CONSTRUCTION PLANS
FOR
CREEKSIDE AT LORSON RANCH FILING NO. 2
STREET AND STORM SEWER CONSTRUCTION PLANS

SF 23-XX

V1_Construction Drawings (Plans_Profiles).pdf Markup Summary

**LOCAL ROADWAY SIGHT TRIANGLE
PUBLIC IMPROVEMENT ESMT.**
NOT TO SCALE

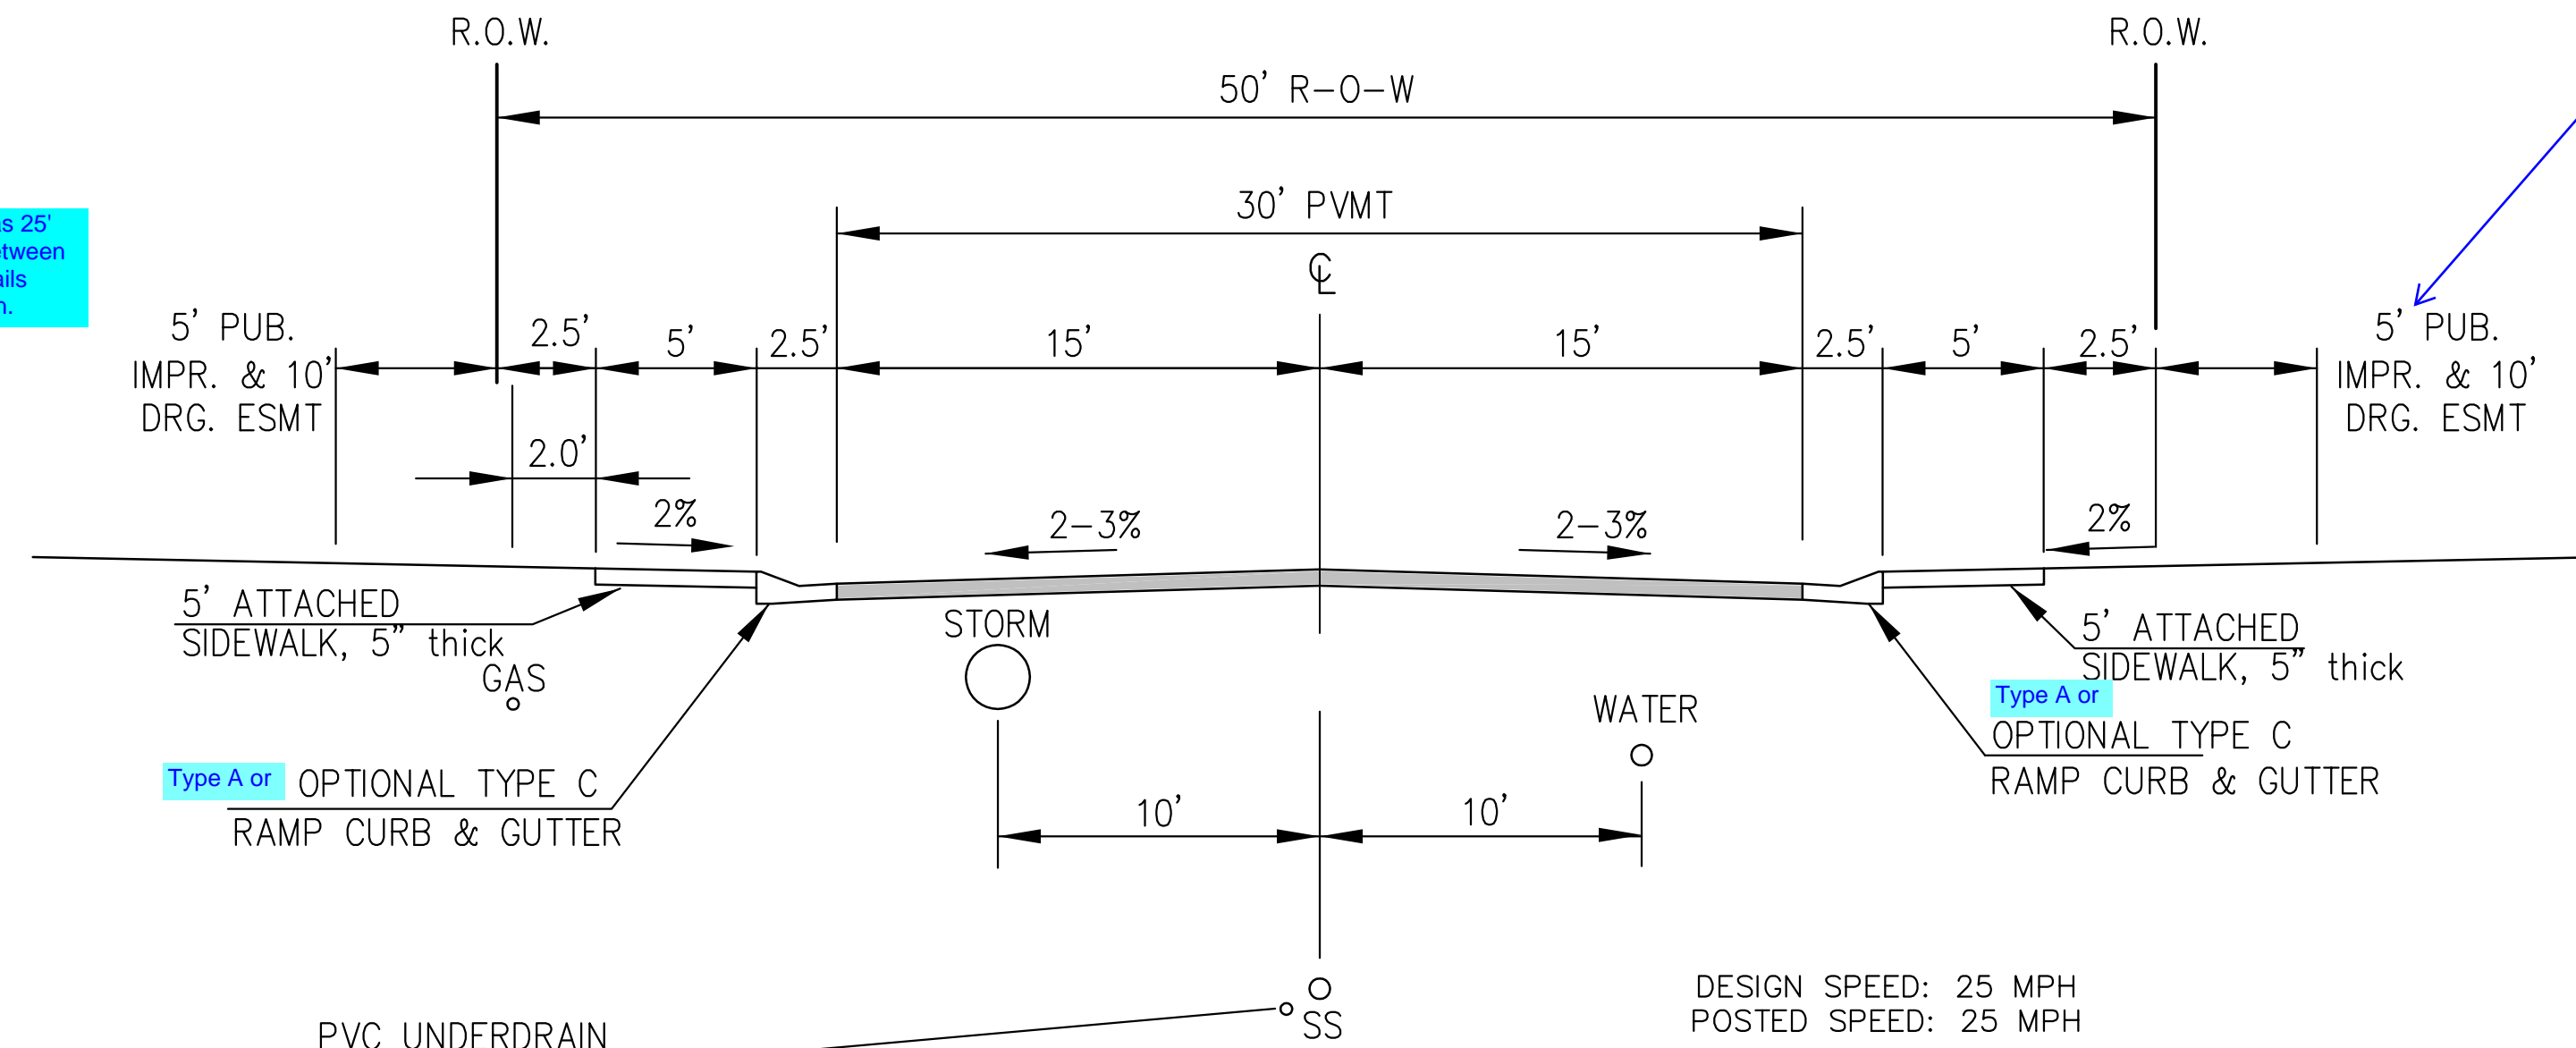
Plat shows min distance as 25' min. Please coordinate between this sheet and plat so details have the same information.

**TYPICAL SECTION 50' R.O.W.
RESIDENTIAL URBAN LOCAL**
NOT TO SCALE

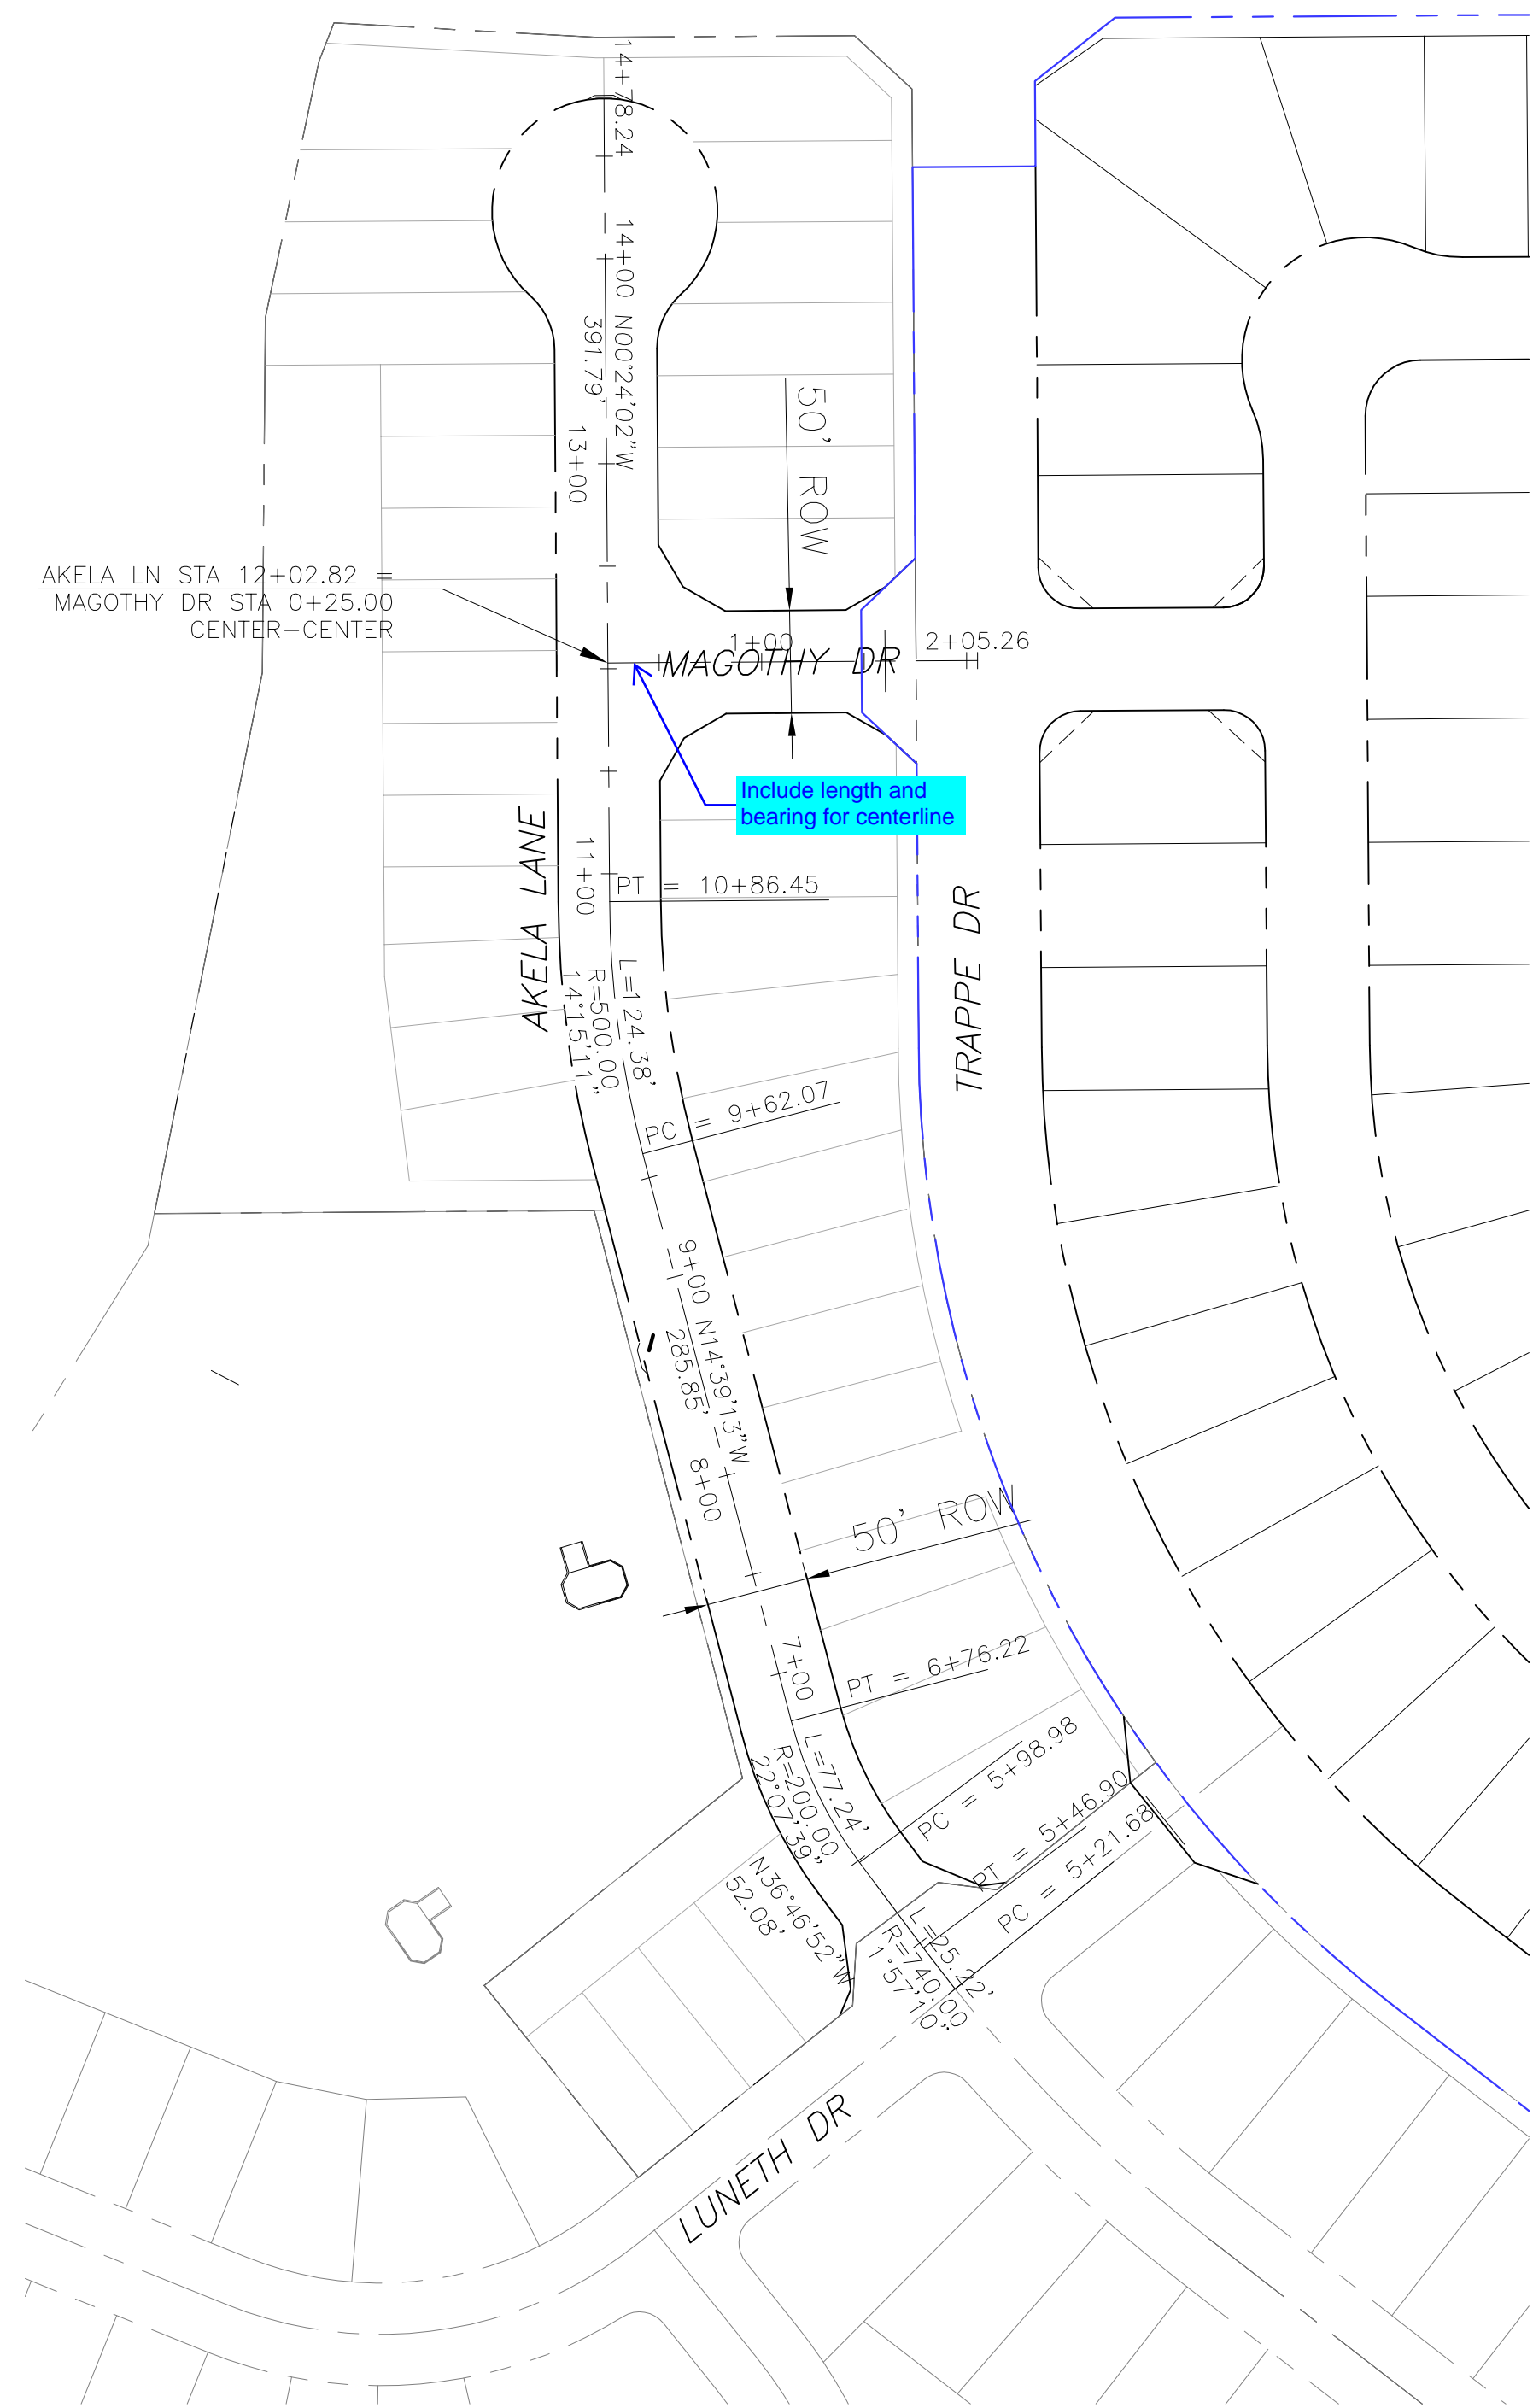
Per typical section on GEC plan set, public improvement easement is 10'. Update sections between plan sets to be consistent.
